Assessment Report Section 4.55(1A) Modification

**SSD 7348 Modification 6
2 Aldington Road, Kemps Creek**

Prepared for Goodman Property Services (Aust.) Pty Ltd
Submitted to Department of Planning, Industry, and
Environment

November 2020

Figure 2: Proposed Masterplan Layout (Source: SBA Architects)

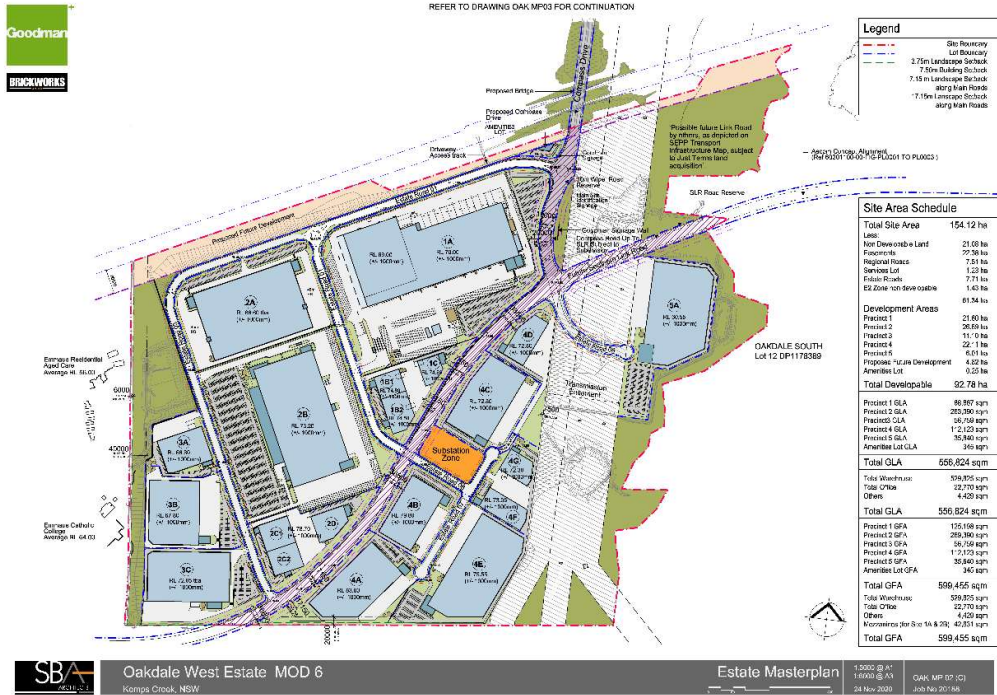
- Increase in height of Building 2A from 15 m to 18 m, with the maximum approved ridge height to be increased from 13.7 m to 14.9 m
- Minor alterations to building form and layout of Buildings 2A & 2C-2D, resulting from detailed design development
- Minor change to building and lot layout at Precinct 3, including a reduction in buildings from five (5) warehouse to three (3)
- Civil design amended to accommodate changes to Precinct 3
- Removal of road speed limits in the consent, to reflect Penrith City Council and Transport for NSW requirements
- Minor changes to VMP area
- There are no proposed changes to road layouts or any other development controls.

The proposed modified Concept Plan layout is shown in Figure 2 and the proposed modified Stage 1 DA layout is shown in Figure 3, with both included in Appendix 1 (Masterplan) and Appendix 1A (Stage 1). Amended civil engineering plans are provided in Appendix 2A (Masterplan) and Appendix 2B (Stage 1), with a supporting Civil Report in Appendix 2.

Figure 3: Stage 1 DA layout changes (Source: SBA Architects)

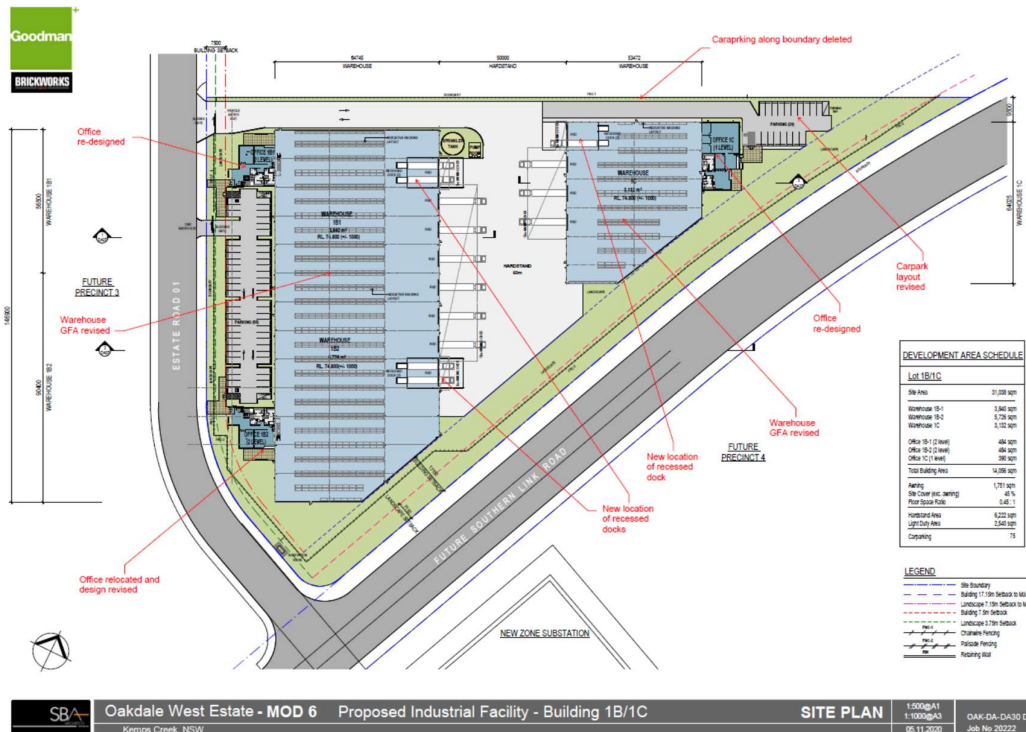
- Construction of Estate Road 8 in its approved alignment under the Concept Plan Approval, as part of the Stage 1 works
- Minor architectural changes to buildings 1B and 1C (see Table 3 and Figure 3)
- Changes to area identified for offsetting in Vegetation Management Plan

Element	Approved (as modified)	Proposed	Change
Warehouse 1B-1 area	3,840 m ²	3,854 m ²	+14 m ²
Warehouse 1B-2 area	5,726 m ²	5,686 m ²	-40 m ²
Warehouse 1C area	3,586 m ²	3,132 m ²	-454 m ²
Office 1B-1 area	484 m ²	500 m ²	+16 m ²
Office 1B-2 area	484 m ²	569 m ²	+85 m ²
Office 1C area	390 m ²	436 m ²	+46 m ²
TOTAL	14,510 m²	14,177 m²	-333 m²
Awning	1,751 m ²	1,400 m ²	-351 m ²
Site cover	45%	47%	+2%
FSR	0.45:1	0.47:1	+0.02
Hardstand area	6,222 m ²	6,445 m ²	+223 m ²
Light duty area	2,540 m ²	2,365 m ²	-175 m ²
Carparking spaces	75	83	+8

The proposed changes to Buildings 1B and 1C (Table 3 and Figure 3) comprise minor revisions to the layout and GFA of offices and carparking, revised locations of recessed docks and amended water tank and pump layout. The layout and scale of these warehouse buildings is generally consistent with the approved Stage 1 layout and there are no proposed changes to setbacks, building heights or access.
